Electronic Silk Road (Shenzhen) Tech Co., Ltd**Declaration of Product Modifications**

This is to request a Class II permissive change for FCC ID: 2APEW-2B528 originally granted on 08/13/2025.

Original EUT	New EUT

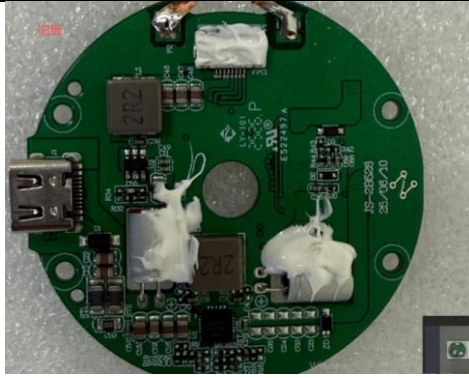
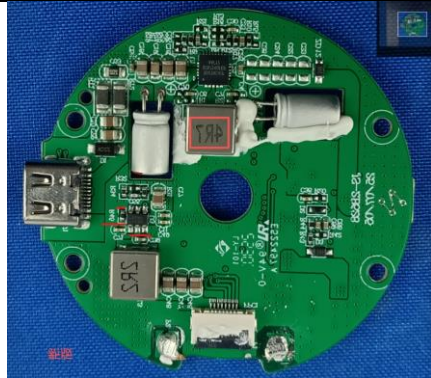
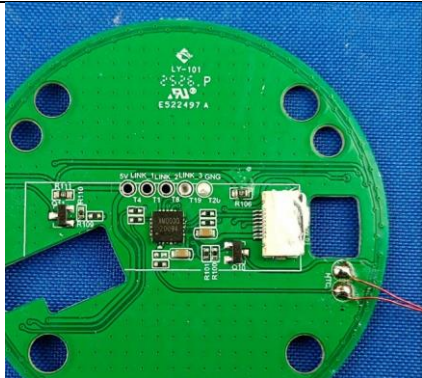
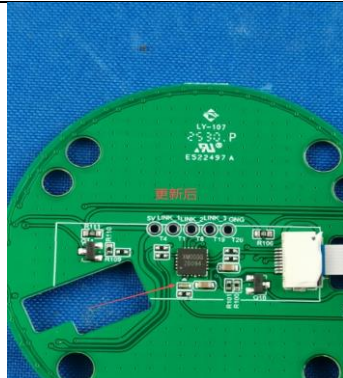
Modified information included adds R45, C71 and R58 components. And update the parameter information and internal photo of inductor L1. After evaluation, the radiated emissions (30MHz-1GHz) test was conducted. The original test data is not affected.
